# Access Compliance Report

## Public Rights-of-Way

Intersection ID: 31277	Main Street: GARRETT_GRIGG_RD	Cross Street: TIGER_LN	Location: S
ADA ID: 425A4778CDA9	Ramp Type: PerpDiag	Initial Pass/Fail: Fail	Overall Compliance: No
			Severity Score: 33.75

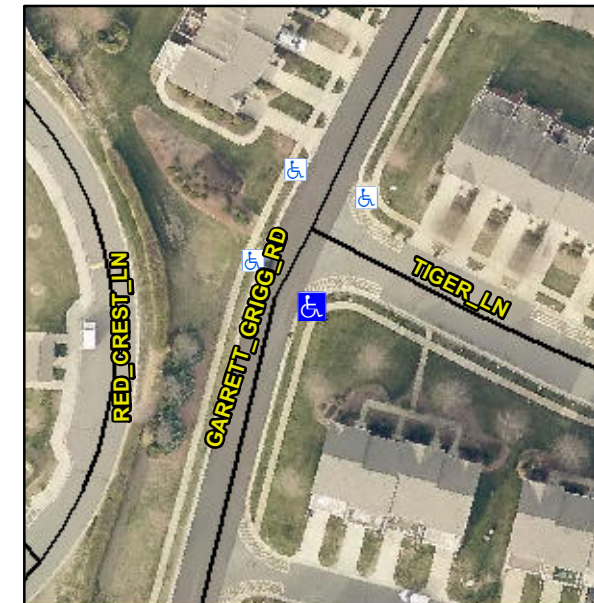
**R304.5.1, R304.5.3**

Compliance	Description	Data	Compliance	Description	Data
N/A	Ramp Length (in)	62.0	Yes	Ramp Slope (%)	5.1
No	Ramp Width (in)	40.5	No	Ramp XSlope (%)	9.8
N/A	Flare Type LT	N/A	N/A	Flare Type RT	N/A
N/A	Flare Slope LT (%)	N/A	N/A	Flare Slope RT (%)	N/A
N/A	Flare Traversable LT?	N/A	N/A	Flare Traversable RT?	N/A
N/A	Landing Length (in)	N/A	N/A	DWS Provided?	N/A
N/A	Landing Width (in)	N/A	N/A	DWS Contrast?	N/A
N/A	Landing Slope (%)	N/A	N/A	DWS Length (in)	N/A
N/A	Landing X Slope (%)	N/A	N/A	DWS Full Width?	N/A
N/A	Landing Curb? (Y/N)	N/A	N/A	DWS Offset (in)	N/A
N/A	Shared Landing?	N/A			
N/A	Gutter Ponding?	N/A	N/A	Gutter Slope (%)	N/A
N/A	Gutter Lip Ht (in)	N/A	N/A	Gutter X Slope (%)	N/A
N/A	Painted X Walk1?	No	N/A	Painted X Walk2?	No
	X Walk 1 Direction	To NE		X Walk 2 Direction	To NW
N/A	X Walk 1 Width (in)	N/A	N/A	X Walk 2 Width (in)	N/A
	X Walk 1 Slope (%)	5.5		X Walk 2 Slope (%)	4.5
	X Walk 1 X Slope (%)	3.9		X Walk 2 X Slope (%)	4.6

**Remove & Replace Curb Ramp With Two New Directional Ramps or Equivalent.**
